Intermodal Logistics Centre at Enfield

**Modification Application No. 5
On Site Management of
Unsuitable Engineering Fill
Response to Submissions**

August 2011

ILC – E – PT3A – Mod Application 5 Response to Submissions Final v1.0 1 August 2011

FIGURE 1.1
ILC AT ENFIELD
LOCATION OF "MT ENFIELD"
WITHIN THE ILC AND SURROUNDING LAND USES

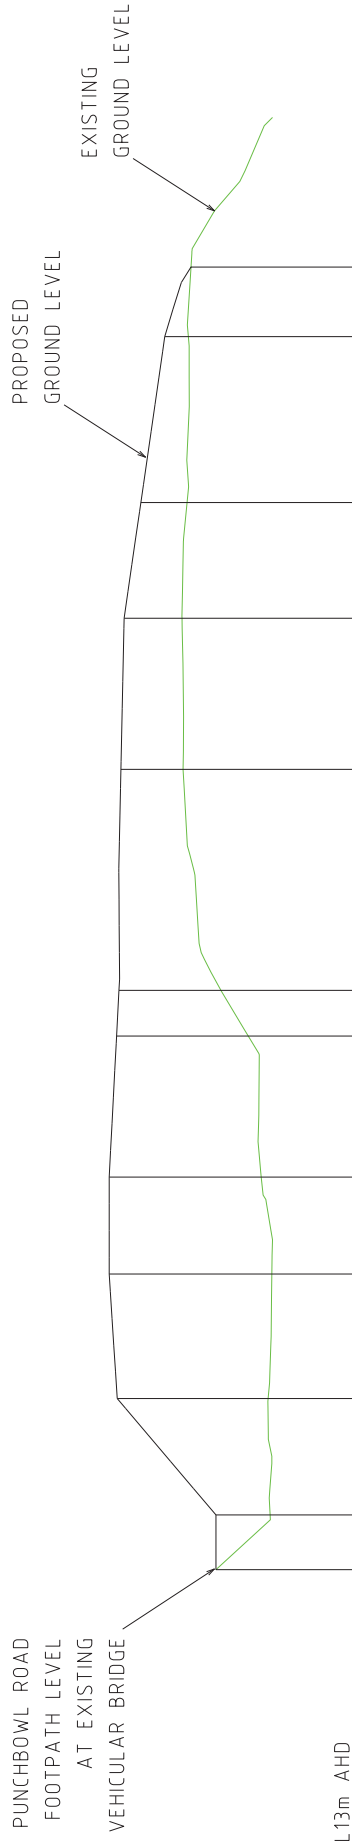
Figure 1.1 is inaccurate and a large area of land identified as 'recreational' on the southern side of Cooks River opposite Dean Reserve is actually industrial and will be developed in the near future.

- the area opposite Dean Reserve is now shown as industrial in Figure 1.1;
- text has been included in Figure 1.3 to indicate that the level identified as “Punchbowl Road footpath level” is the level at the vehicular bridge crossing over the railway yards;
- the typographical error in Figure 1.4 has been corrected.

FIGURE 1.3
ILC AT ENFIELD
FILL REUSE AREA LONG SECTION
 DRAFTED BY: J.T. DATE: 21/07/2011 PLAN SCALE: AS PER SCALE BAR
 PROJECT CODE: ILC-ECHDR-C-FIG 1.3 Mod 5 DWG NO: SEDP170A

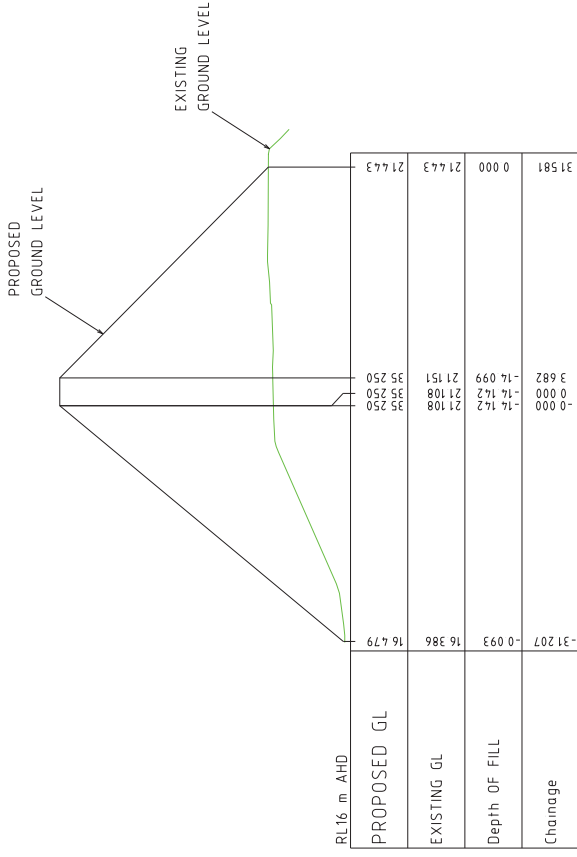
The information in the modification report relating to height also appears to be misleading and requires further clarification. Contrary to section 2.1 which identifies a rise of approx 6.7m at its highest point, according to the long section provided in figure 1.3, the highest point of the proposed ground level appears to be 35.2 with an existing ground level of 21.1 which results in a 14.1m high difference. This is significantly greater than the 6.7m rise identified.

The fill reuse area long section shown in Figure 1.3 is misleading given that the level identified as 'punchbowl rd footpath level' is actually approximately the highest point on the existing vehicular bridge crossing over the railway yards. This bridge is quite evident in the existing landscape and to note that the proposed mound will be more than 10m higher than the existing bridge level, the proposed mound will be visually intrusive on the

A long section and three cross sections are provided in Modification Application 5 showing the existing and proposed elevations for the mound. The increase in height varies depending on the location of the fill emplacement area. The rise of 6.7 m described in Section 2.1 of Modification Application 5 refers to the difference between the **highest point of the existing mound** (29.369 m AHD at long section CH 178 approx) and the **highest point of the proposed mound** (36 m AHD between long section CH 55.41 to 73.57). Note that the highest point of the existing mound in the topographic model is 29.369 m AHD but the chainage of this point is not recorded on Figure 1.3.

FIGURE 1.4
ILC AT ENFIELD
FILL REUSE AREA CROSS SECTIONS
 DRAFTED BY: JLT DATE: 03/05/2011 PLAN SCALE: AS PER SCALE BAR
 PROJECT CODE: ILC-EQLOR-C-Fig 1.4 Mod 5 DWG NO: SEDP171A

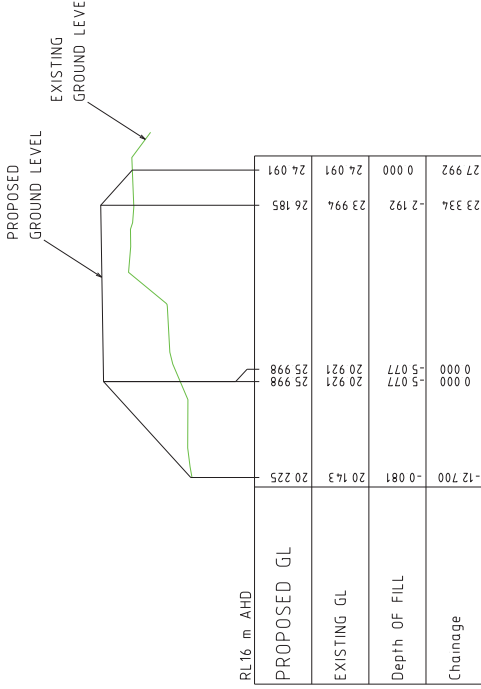
It also appears that the slopes of the proposed mound are too steep for planting. The cross section at chainage 23 identified in figure 1.4 for instance identifies a very steep banked proposed mound. With an estimated 42.5m vertical : 34.5m horizontal = grade of approx 1:2.5. recommended planting grade is 1:10. the slopes are too steep to accommodate for suitable grading for planting, this can pose significant scouring and sediment loss particularly in rainfall events where the steepness of the slopes will cause excessive scouring.

Figure 1.2 identifies a cross section at chainage '32' however the cross section provided in figure 1.4 is identified as chainage 23. This should be clarified as to the exact location of the section.
